Application 3/2021/0275

Location: Land behind The Dog Inn, Market Place, Longridge PR3 3RR

Proposal: Proposed erection of 9 new dwellings and associated works

I refer to the latest letter from United Utilities dated 19th June 2024 in which further additional information has been requested to be submitted in support of the application.

PROPOSED DRAINAGE LAYOUT

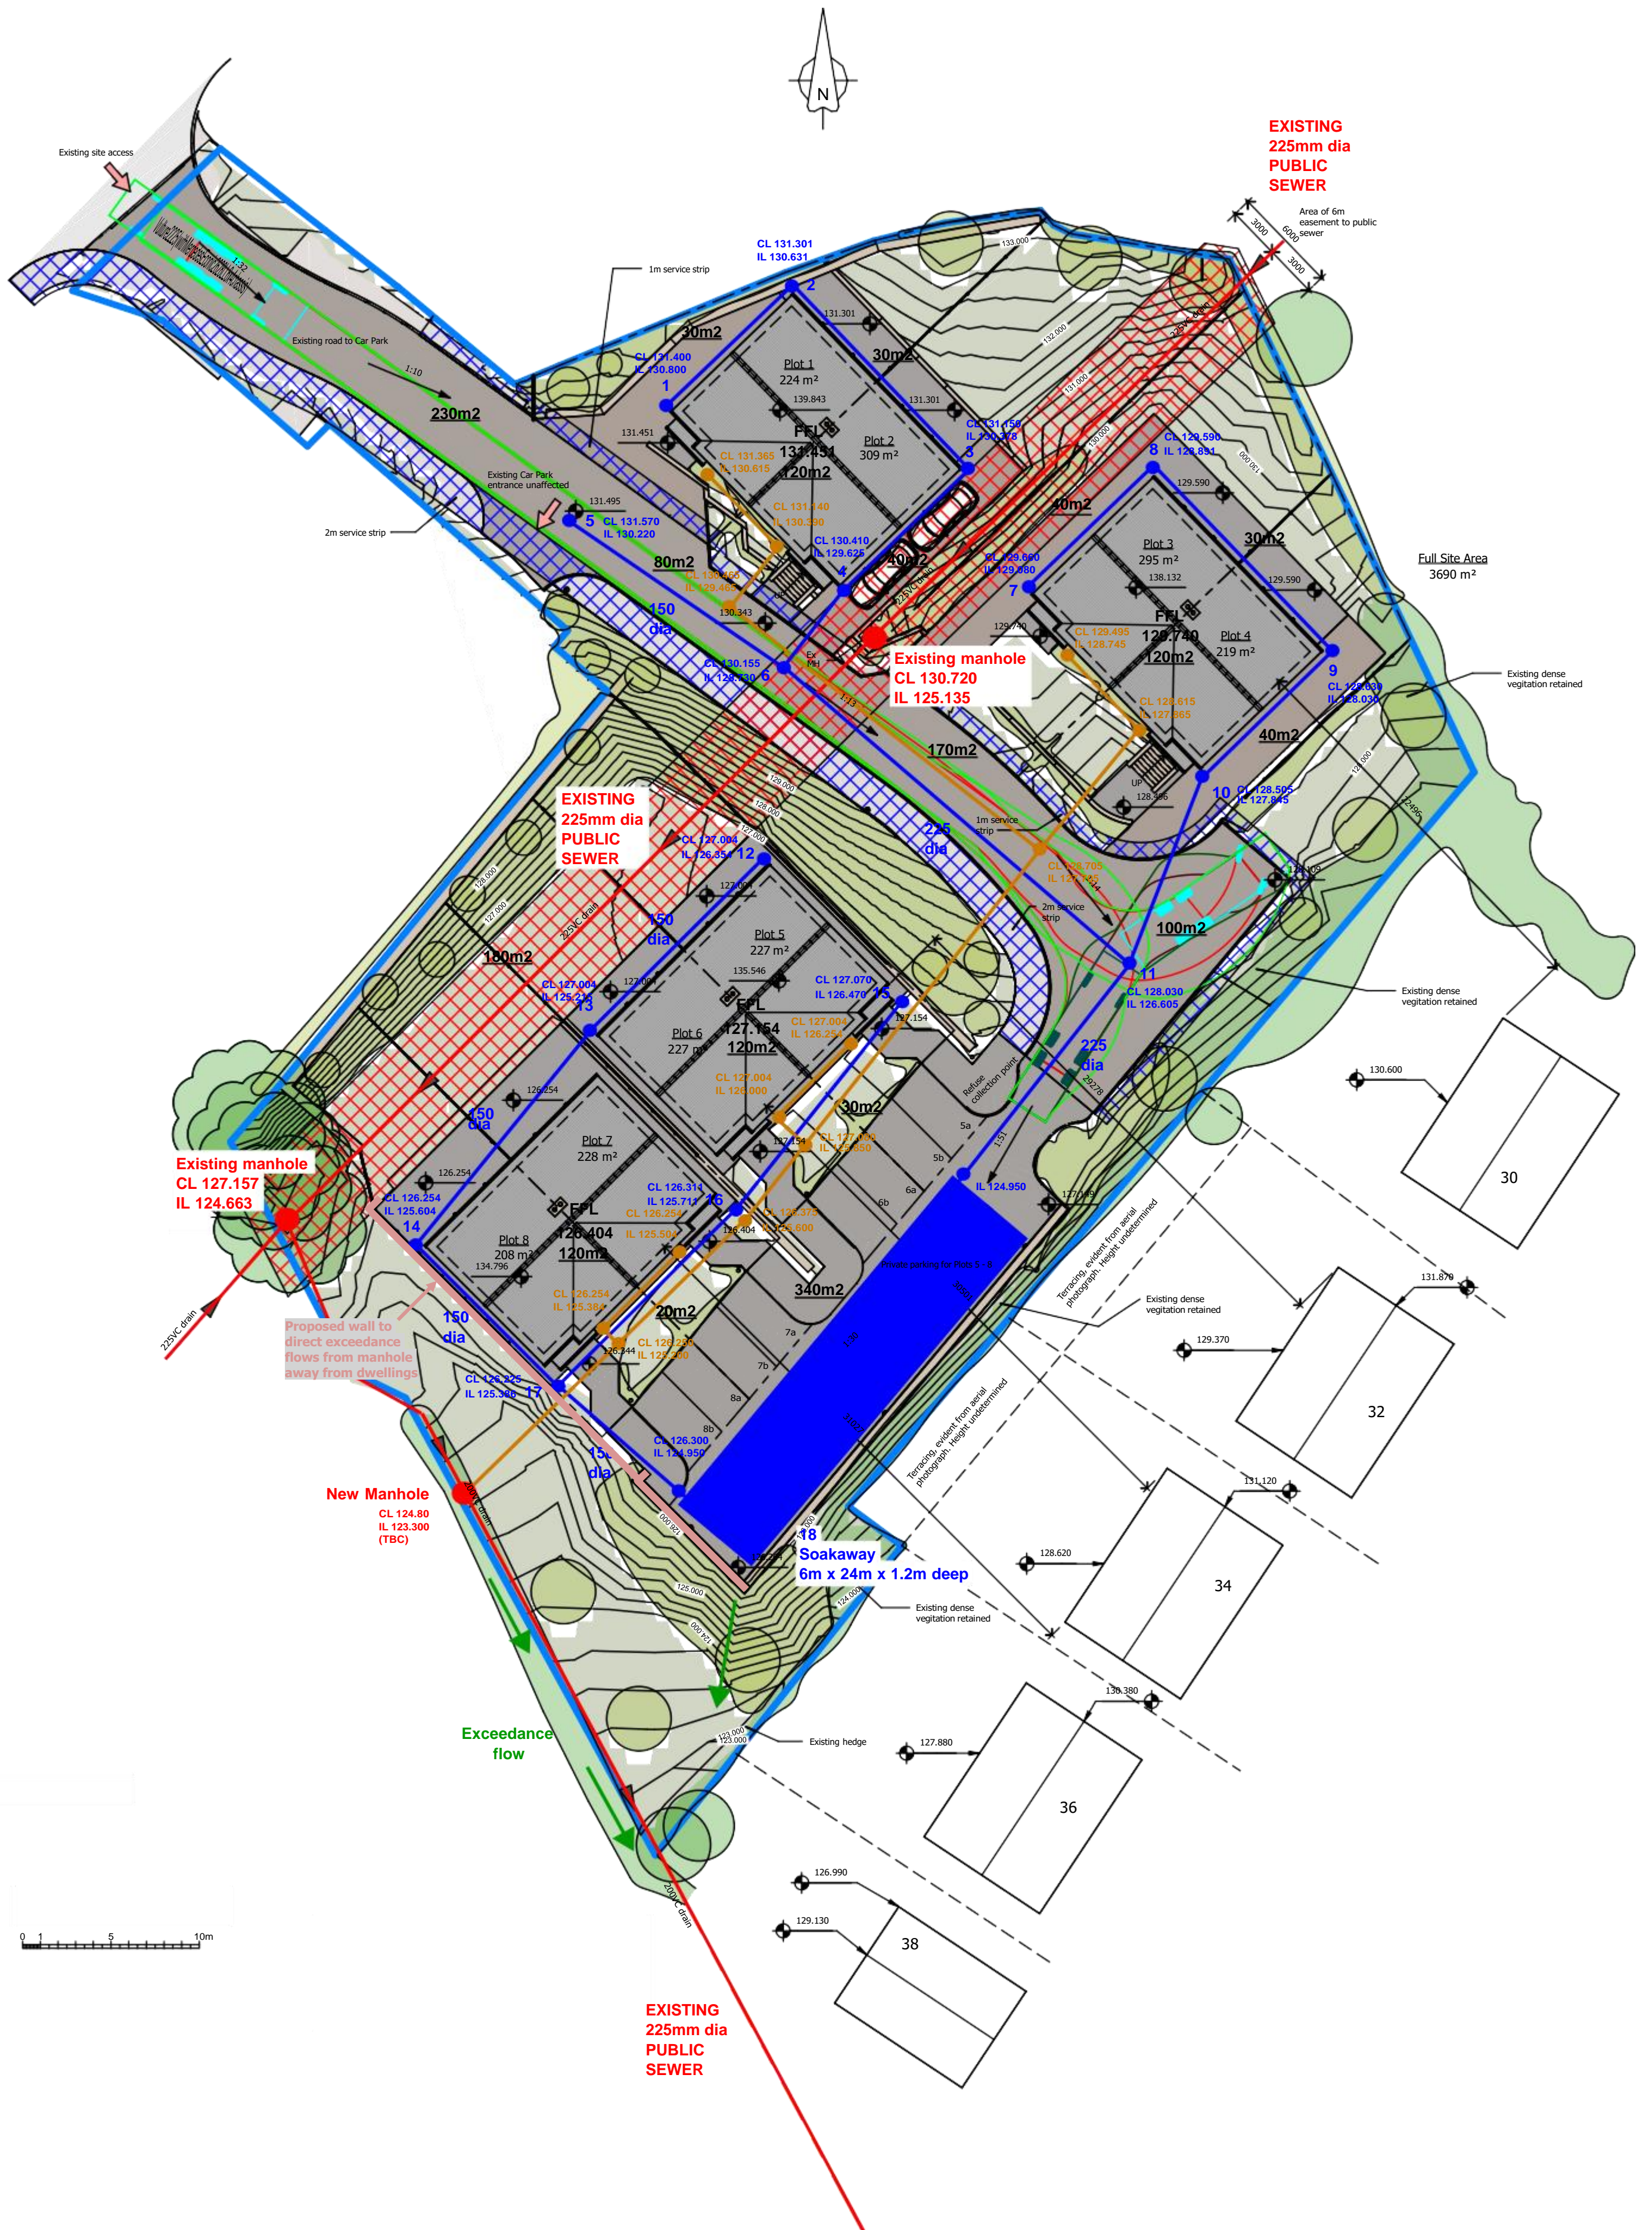
Following our review of the submitted Drainage Strategy, and further to the previous comments we have provided in relation to this application, we note that exceedance flow paths have been shown for the proposed new manhole on the western boundary of the site, however it does not include overland flow paths from the existing manhole MH6102. The cover level for MH6102 is 127.157 AOD however the proposed finished flood levels for Plots 7 and 8 are 126.404 AOD. We request that the applicant confirms the flood exceedance path from this manhole and, if required, includes measures to ensure that Plots 7 and 8 are not at risk of flooding from the existing manhole, including raising finished floor levels and / or mitigation measures / features to ensure the properties are not at risk of flooding. Noting this is a full

application, and site levels and finished floor levels are intrinsically linked to the proposed site layout, we request that updated information is submitted for our review and comment prior to the determination of this application.

In order to prevent any exceedance flows from United Utilities manhole 6102, it is proposed to extend the boundary wall of Plot 8 along the western elevation to direct any exceedance flows away from Plots 7 and 8 thus ensuring that Plots 7 and 8 will not be at risk of flooding from the manhole. The drainage drawing showing the location of the wall is attached to this letter.
